Central Planning Authority

Agenda for a meeting of the Central Planning Authority to be held on **June 23, 2021 at 10:00am,**
in Conference Room 1038, 1st Floor, Government Administration Building, Elgin Avenue.

CPA/13/21

Figure 1: The site (outlined in blue) is mostly man-modified (beige/brown) with some areas of seasonally flooded mangrove forest (pink).

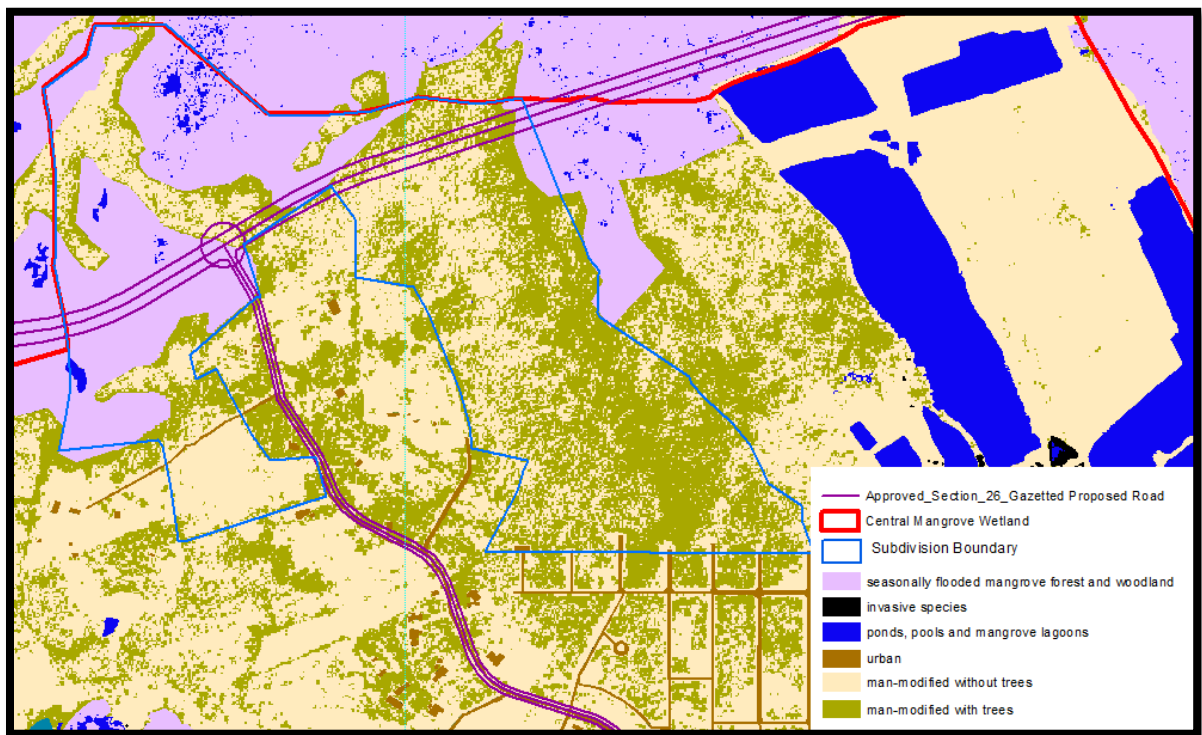
The application site is partially man-modified with areas of primary habitat (seasonally flooded mangrove forest) as shown in Figure 1. The vegetation in the man-modified areas has regrown somewhat and continues to provide an ecological benefit, such as drainage and habitat for native flora and fauna. The application site is also located immediately south of the Boundary of Central Mangrove Wetlands (see Figure 2). Therefore given the size and location of the subdivision, the Department would like highlight the following concerns.

Figure 2: LIS 2018 aerial imagery showing the application site (outlined in blue) and the proposed East-West Arterial road (purple).

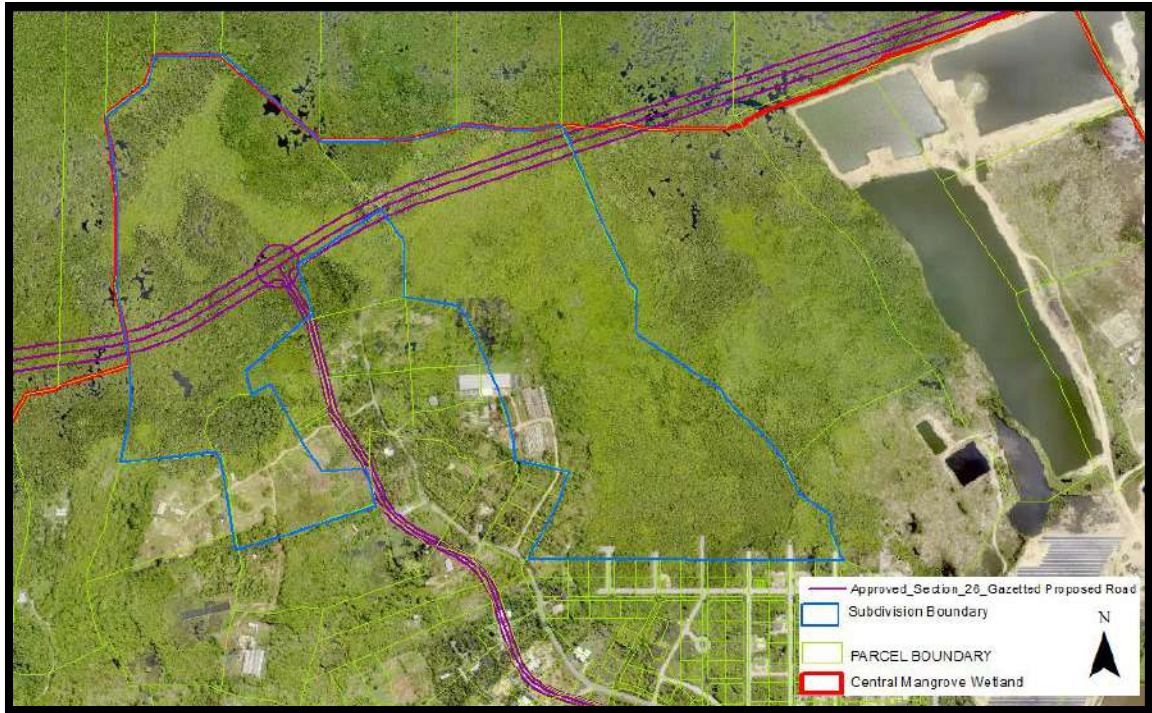
The East-West Arterial from Woodland Drive to Harvey Stephenson Road has been through the EIA screening stage and the EIA scoping stage. The next step in the EIA process is the preparation of the Terms of Reference. However, at the request of the Ministry of Commerce, Planning and Infrastructure (CPI) the scope of the EIA only covers the portion of the road from Woodland Dr to Harvey Stephenson Rd, and not further east.

The outcome of the EIA could impact the subdivision, and the subdivision may also impact the outcome of the EIA. The applicant may have to redesign parts of the subdivision should the location of the road change. Therefore, in the Department's opinion, it is considered that approving the subdivision application without knowing the outcome of the EIA is premature, and would recommend that the application be held in abeyance until the EIA is finalised. A phased approach could also be undertaken, starting with a phase in the south which is not likely to be directly impacted by the final layout and design of the road.

Figure 1: DoE site visit photo from meeting with the applicant on 04 May 2021 showing the proposed location of the ladder at the terminal end of the proposed concrete pathway and the intended point of water entry.

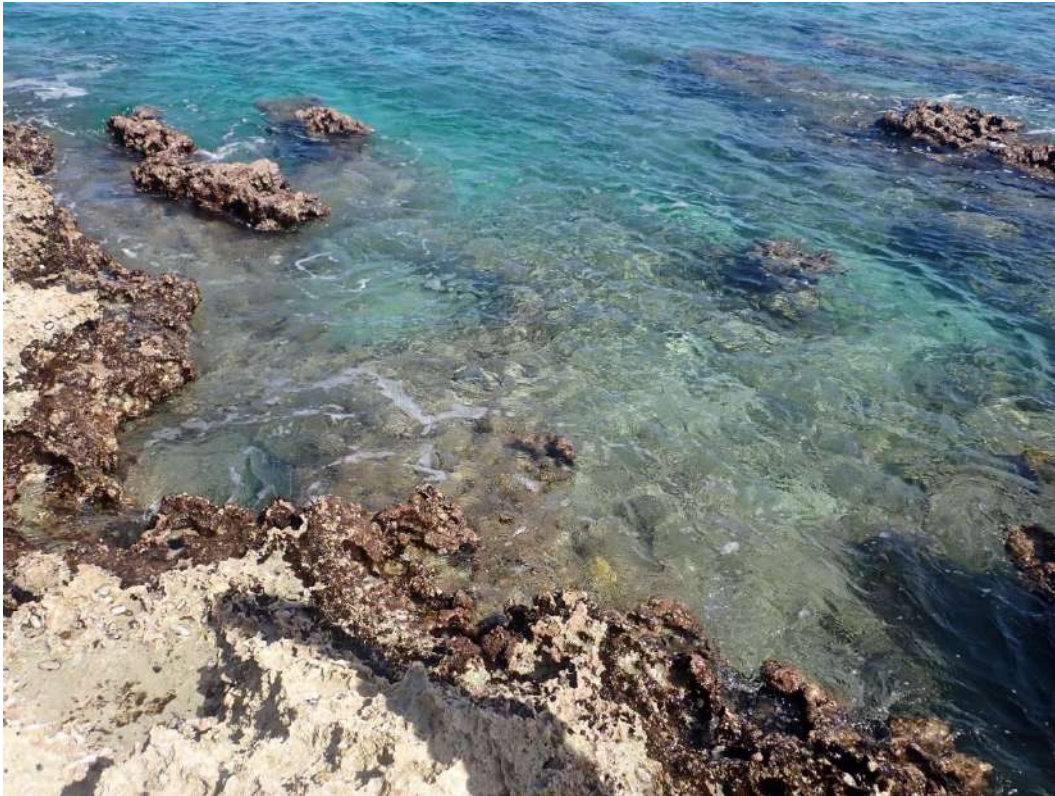
The DoE does not object to the walkway provided that the concrete pathway is confined to the ironshore areas identified in the applicant's site plan. However, the Department does query the feasibility and safety of the area proposed for water entry, particularly for guests equipped with dive gear, given the rock formations present in the proposed area for the ladder (see Figure 1 below). Should the applicant need to modify the coastline beyond its property boundary or install a ladder that extends into the sea, these works must be the subject of a Coastal Works Permit (section 21 of the National Conservation Law, 2013). Any works carried out seaward of the applicant's property boundary, without the necessary Coastal Works Permit, would be in breach of the National Conservation Law (2013).

We are encouraged to see that the applicant has also indicated on their plans their intention to carefully remove any sea urchins within the footprint of the works and relocate them outside of the footprint of the works. All sea urchins species are protected under Schedule 1 Part 1 of the National Conservation Law, 2013.
